ADDENDUM NO. 1
Issued: June 1, 2021

Solicitation #CI 21 B 00608

**Renovation of MHA High Rise Dwelling Units at Barry Towers,
Venson Center, Jefferson Square and Borda Towers, Memphis, TN**

A1.2

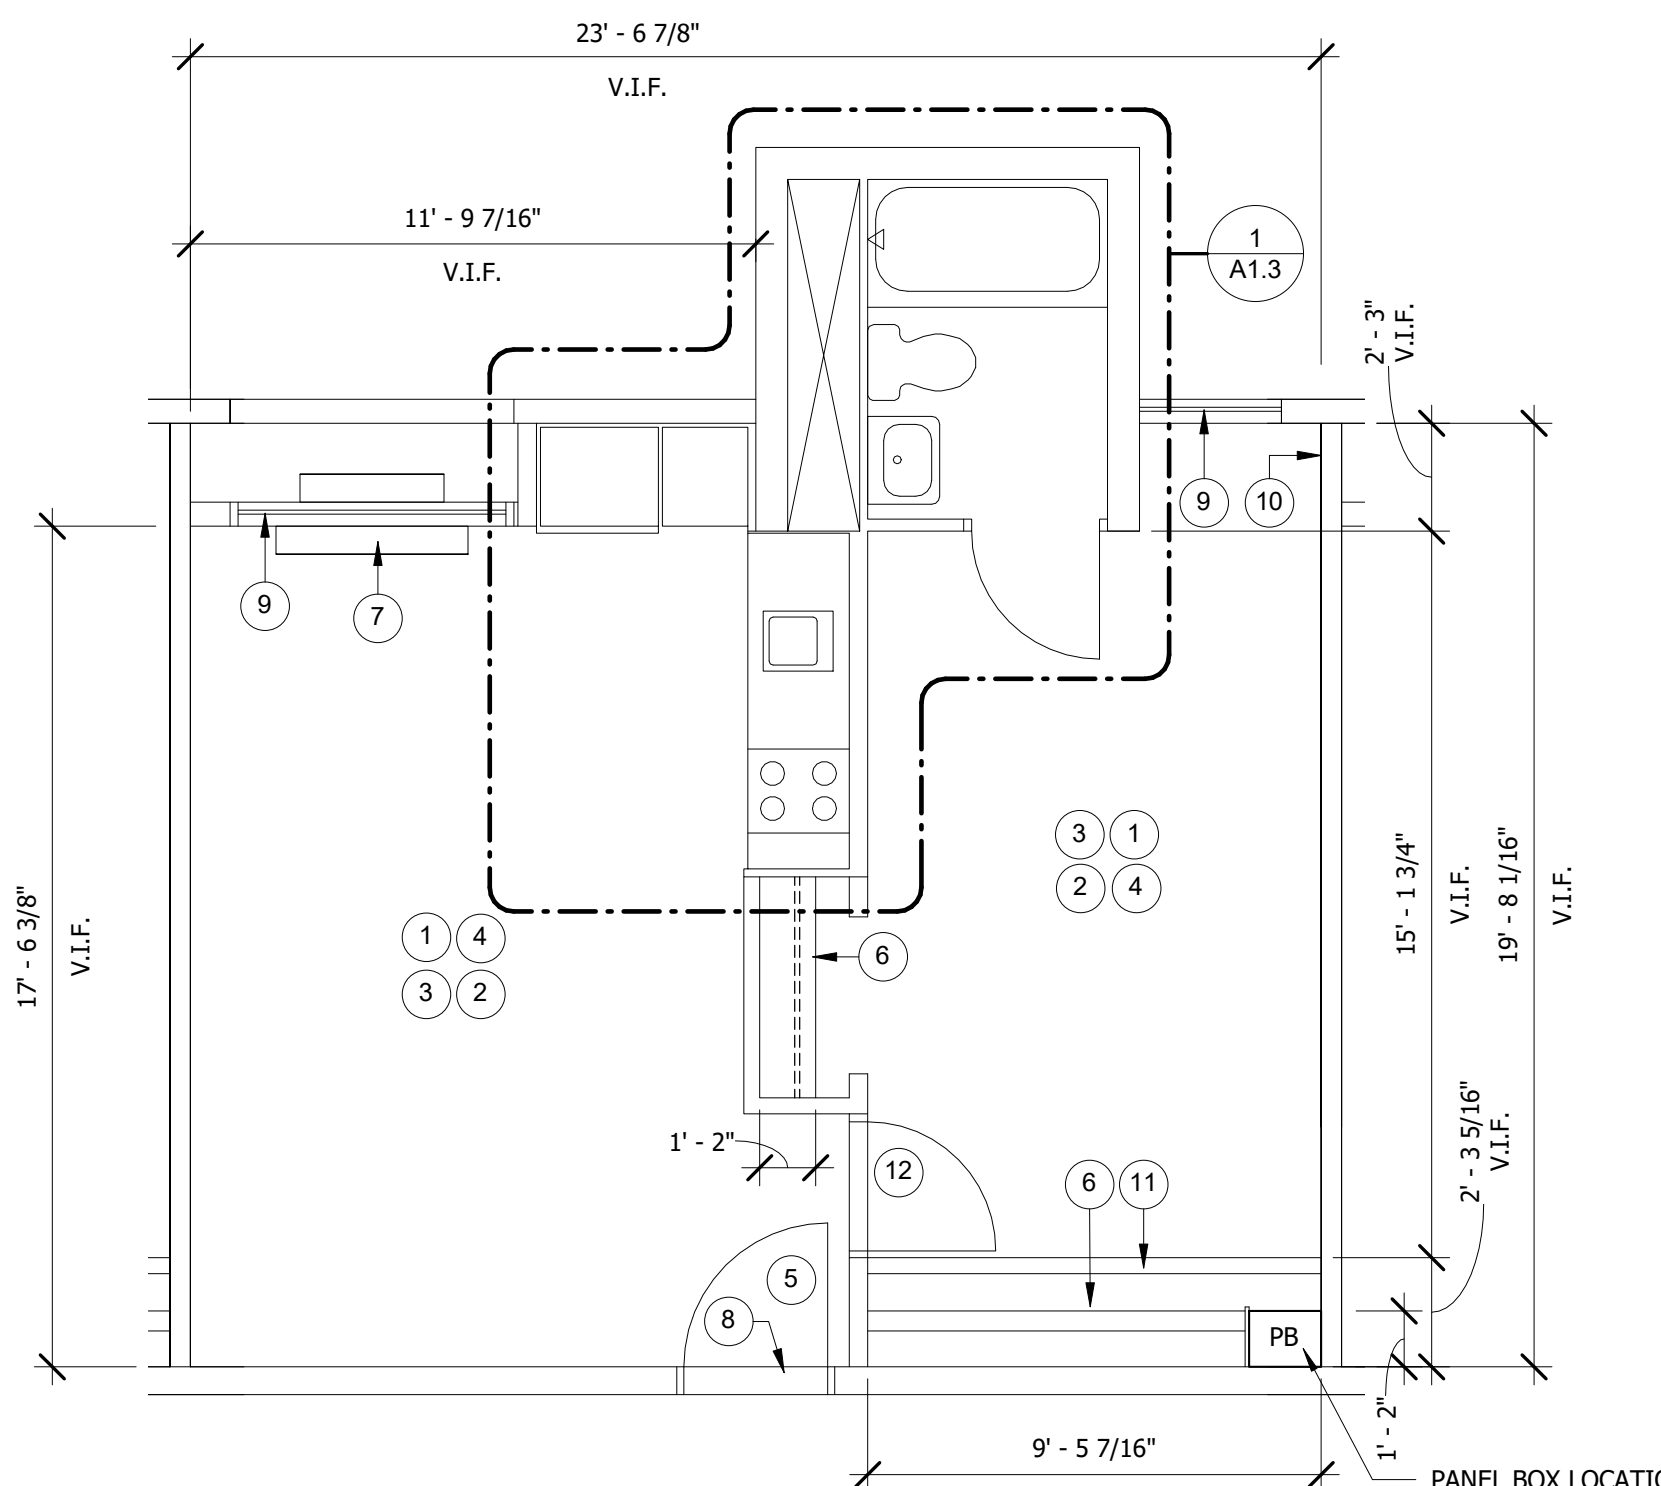
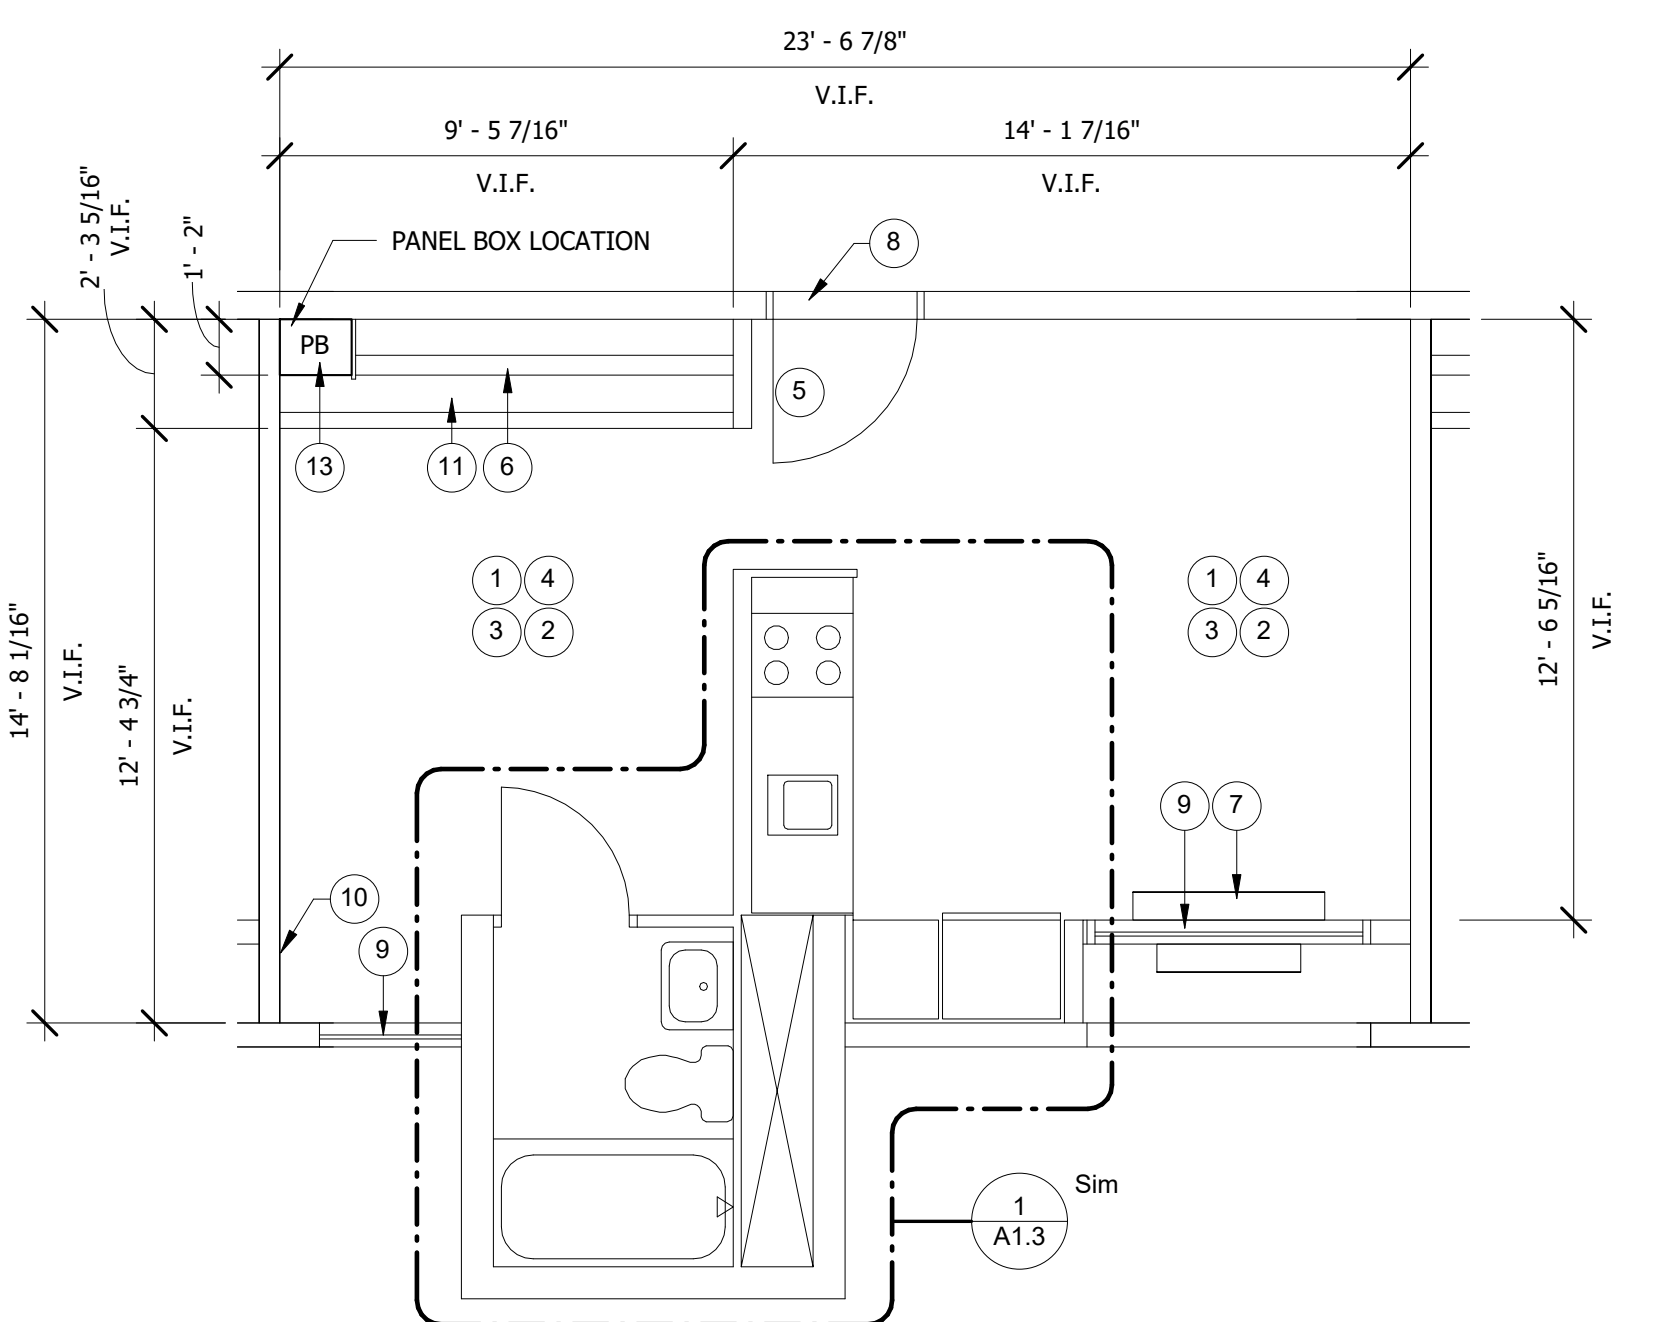
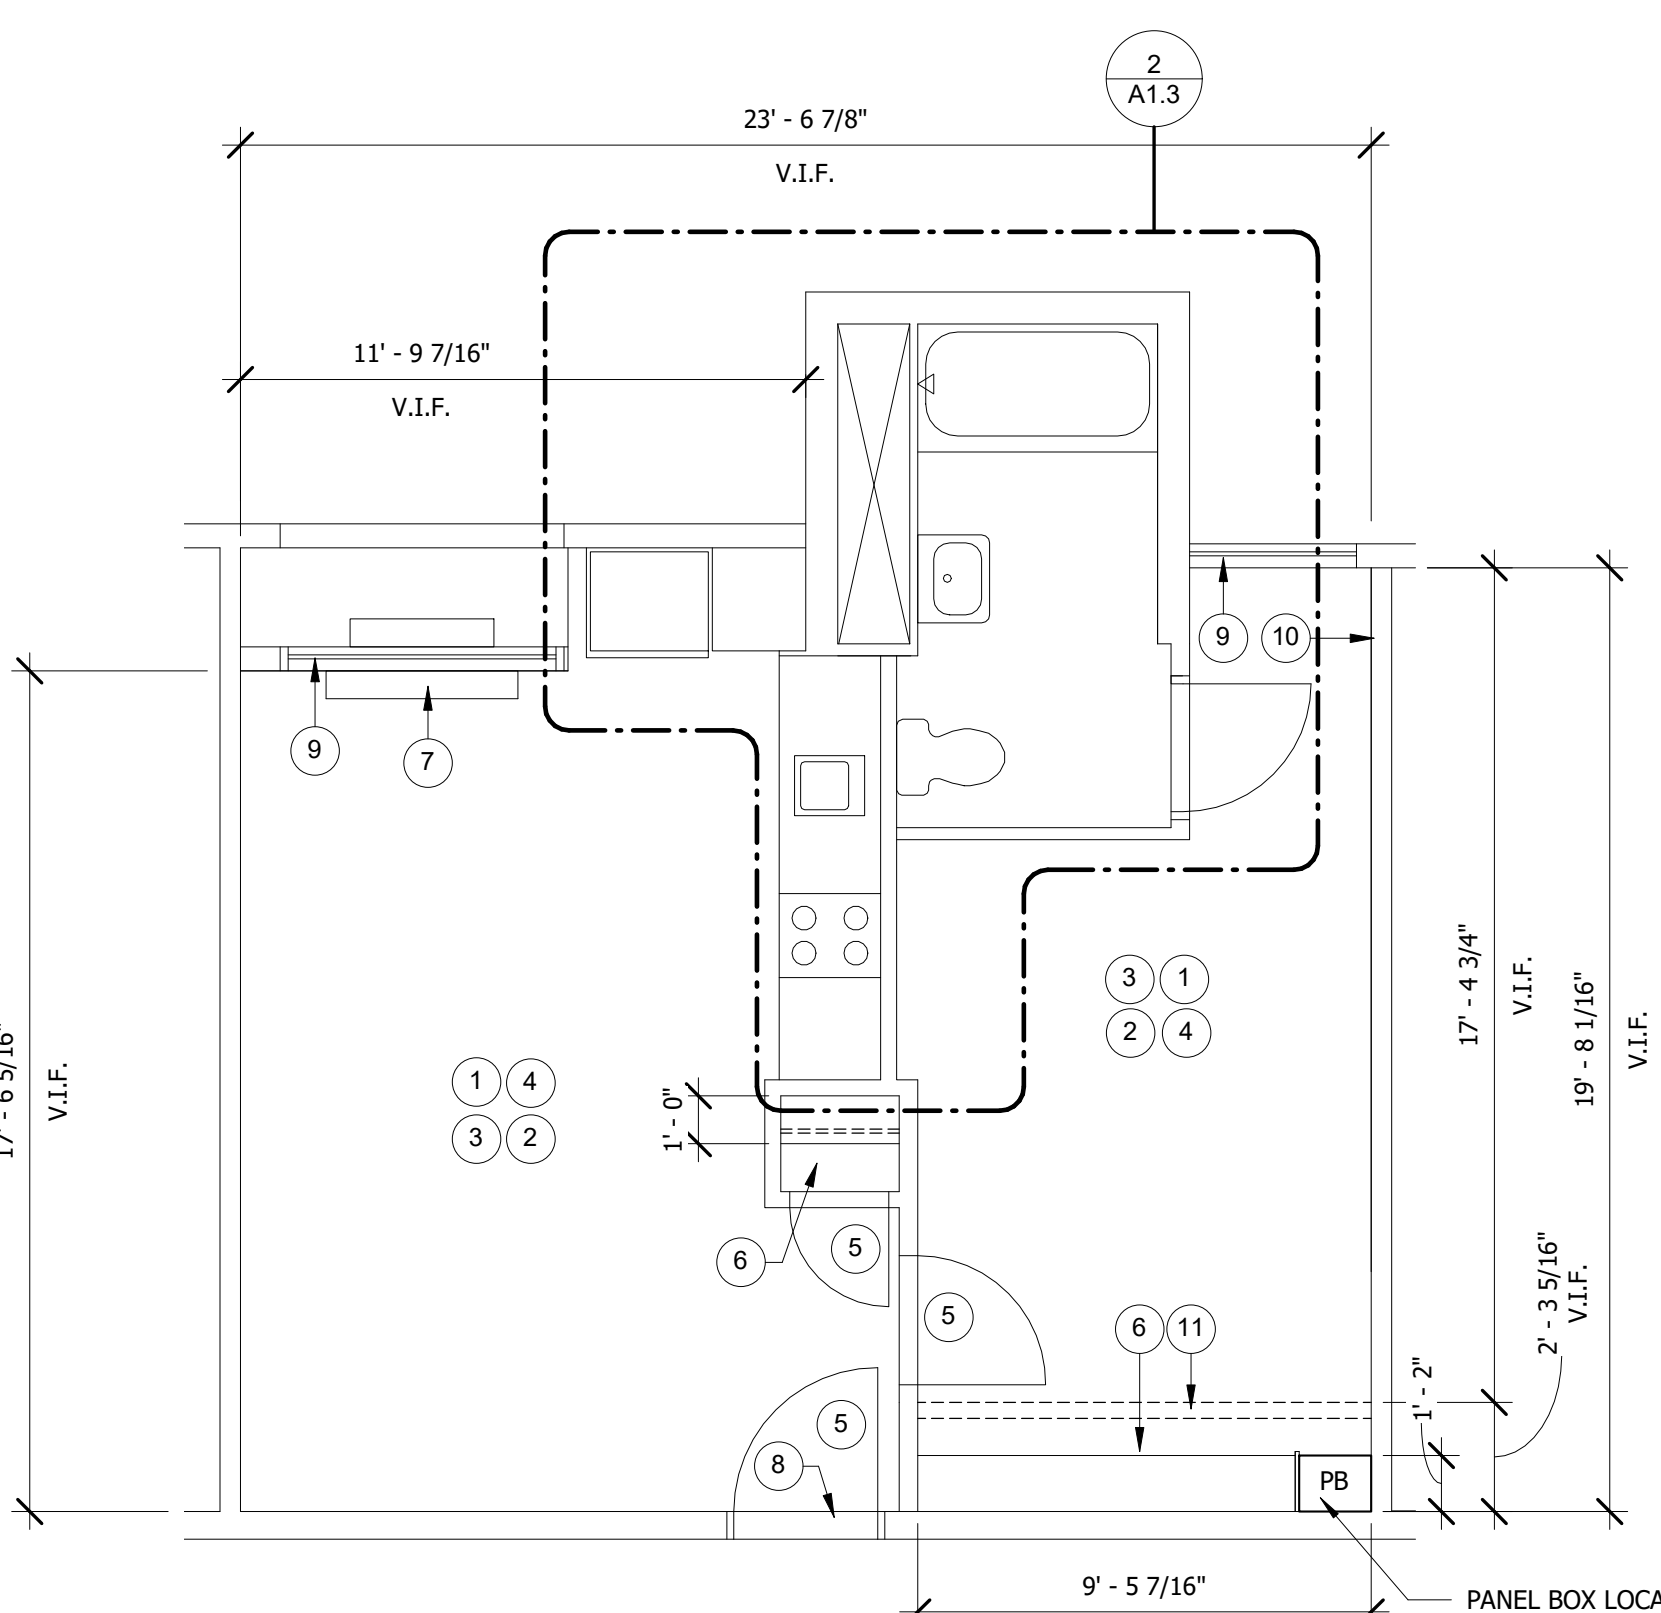
2. A1.2 Plan note 6: Remove all shelving, shelving accessories and hanging rod. The units we reviewed for examples, retained existing shelving.

3. A1.2 Plan note 13: Please confirm this whole note only applies to unit 1415.

RESPONSE: Existing shelving and hanger rods will be replaced in these units per drawings.

RESPONSE: This note in its entirety applies only to unit 1415.
